NinjaNIRS 2026/27 Upgrade Notes

As of July 27, 2026

NinjaNIRS 2026

NinjaNIRS 2027

Backplane

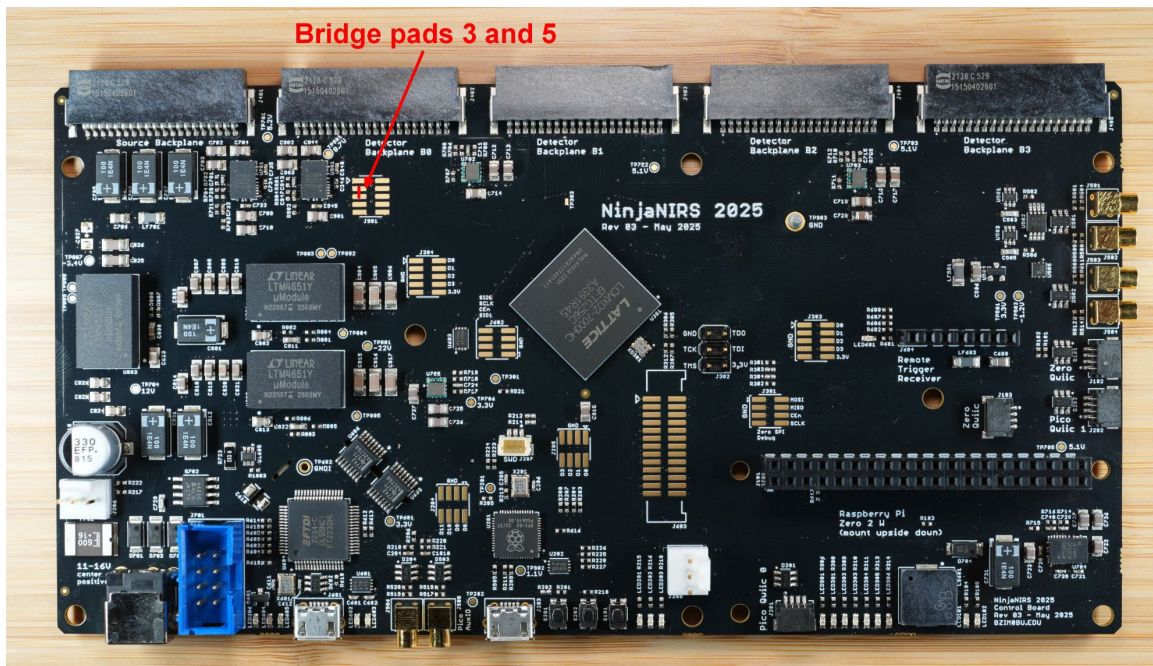
The existing backplanes are compatible.

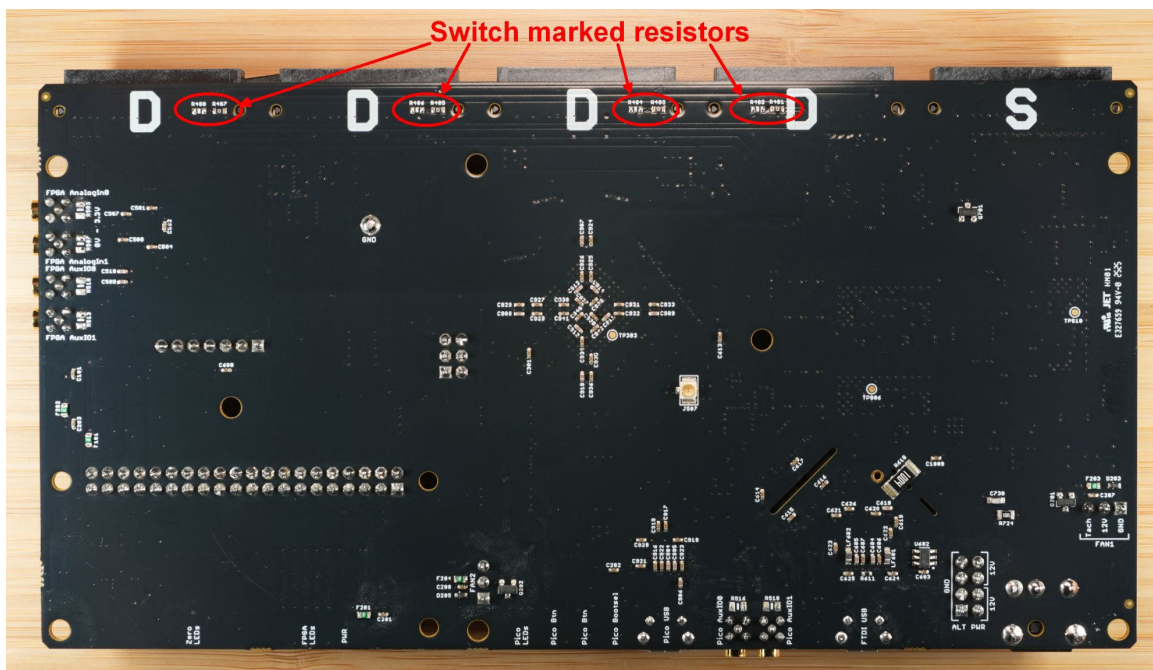
Here are the necessary changes on the v3 control card:

On the front side of the card, bridge pads 3 and 5 of connector footprint J901.

On the back side of the card, move the 0 Ohm resistor from R401 to R402, from R403 to R404, from R405 to R406, and from R407 to R408.
